ADDISON EXPRESS
 HANGER ADDITION
 4500 Claire Chennault
 Addison, Texas

OFFICE AREA
 PLUMBING PLAN
 Scale 1/4" = 1'-0"

DWG NO. addisonP
P-1
 DATE: 06-22-00

FIRST FLOOR PLAN
 (SECOND FLOOR OFFICE RESTROOMS PLUMBING IS SIMILAR)
 El = Finish Floor

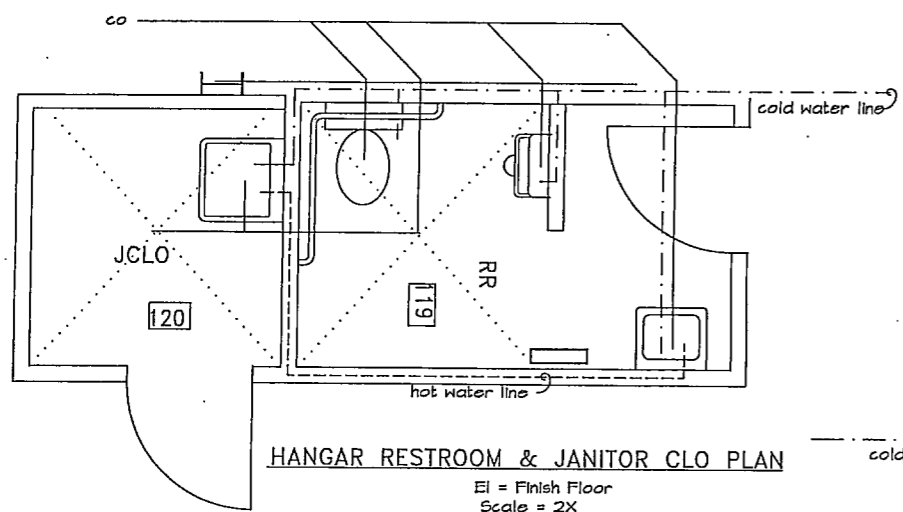
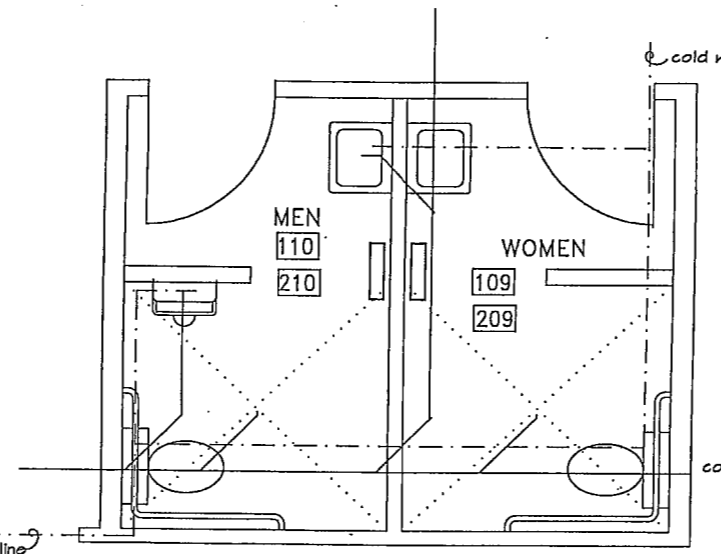
*NOTE: OCCUPANCY SEPARATION
 WALL REQD BETWEEN HANGAR
 & OFFICE. OPENINGS SHALL BE
 PROTECTED AS REQD PER 1997 IBC.
 SUBMIT REMAINDER OF PLANS
 BEFORE CONSTRUCTION. (18)
 1. Elec
 2. Mech
 3. Floor Plan*
